Slightly tighter bmax for CR
(comment 183)

Piers Dawe, Nvidia

IEEE P802.3ck

Backplane and cable (TP0-TP5) channels

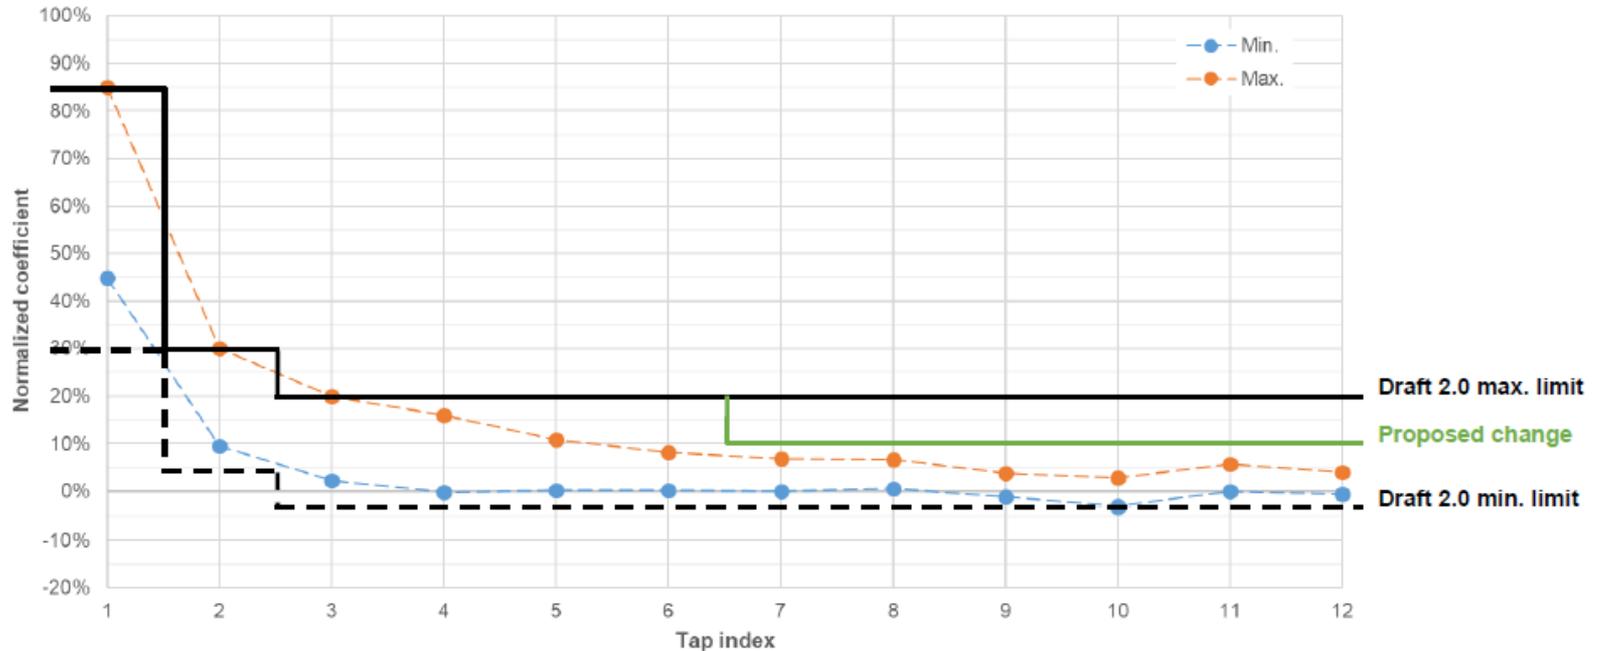
- Only one channel has a strongly -ve tap above 12 UI
- No channels have taps $> \sim 0.03$ above 12 UI

Cable assembly (TP1-TP4) channels

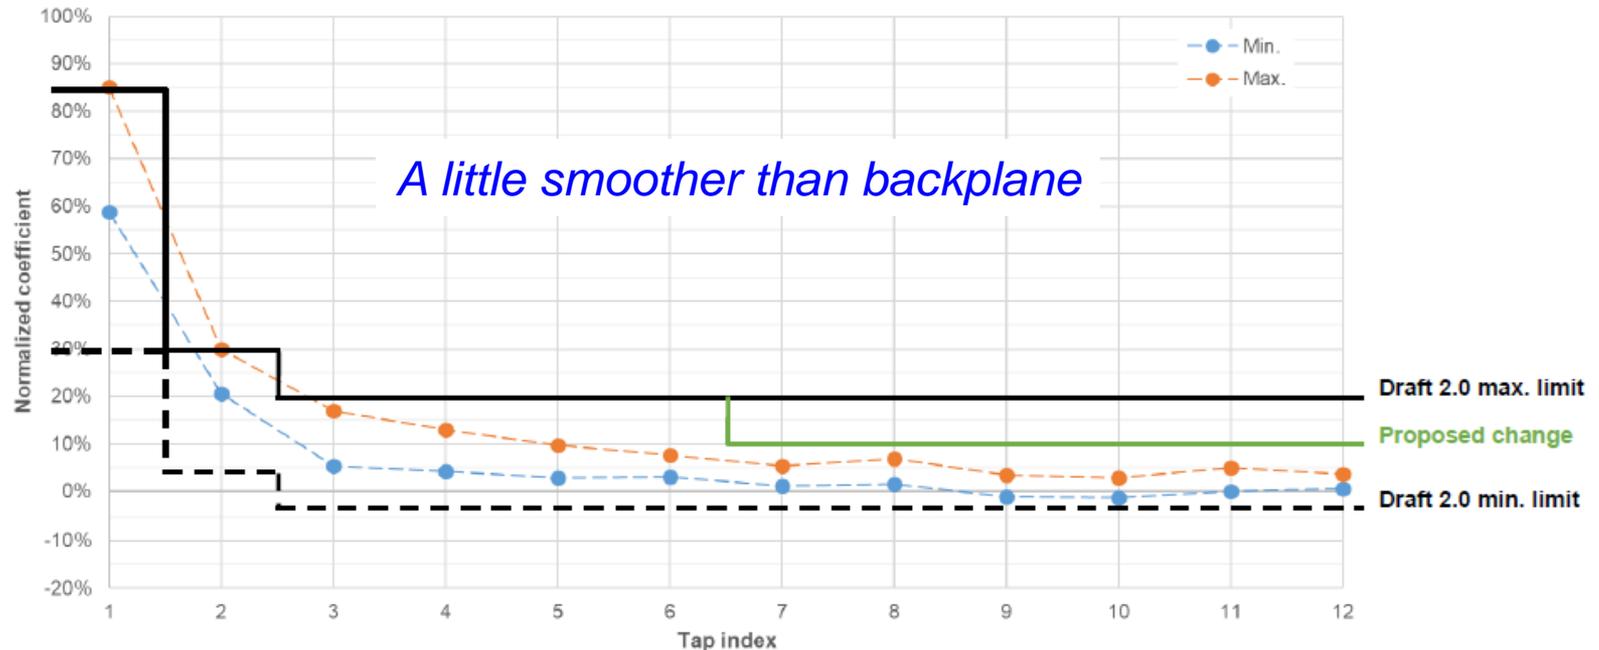
Even at tap 12, a typical tap weight is slightly +ve

Tap limit should be tighter than unconstrained taps observed

From
dawe_3ck_01a_0921

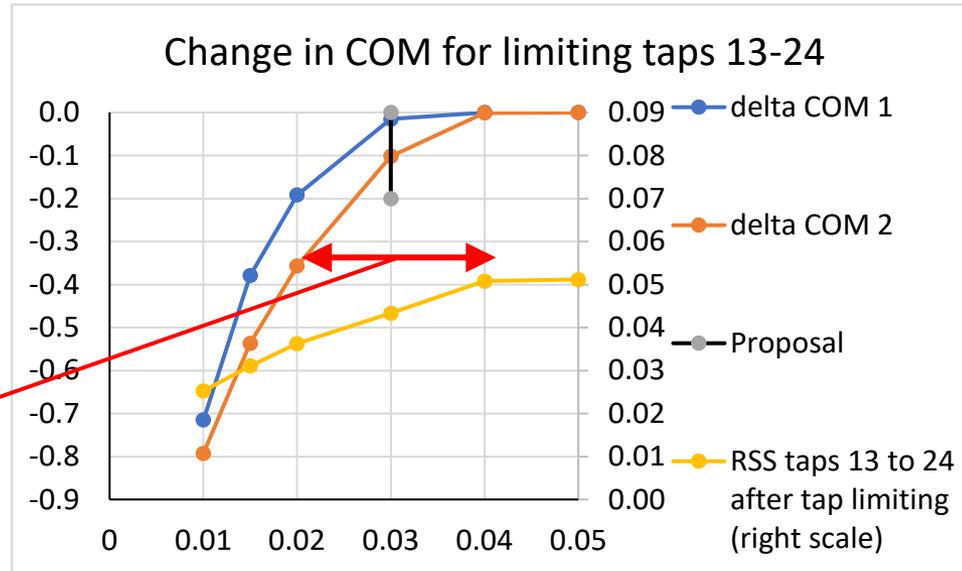
Spec allows channel to have one tap more than 0.02 beyond reference Rx tap limit

This channel -0.0405, could pass easily with -0.06

For limits of 0.02 to 0.01, one then two +ve taps respectively were truncated too, so the roll-off for -ve tap limit as proposed would be a little less than shown

- We should: tighten bbmin(13-24) to reduce COM slightly, at -0.03
- Or: set it tighter to reduce COM for worst reference channel to 3 dB
- Or: align -ve limit for taps 13 to 40 to limit for taps 3 to 12, at -0.03
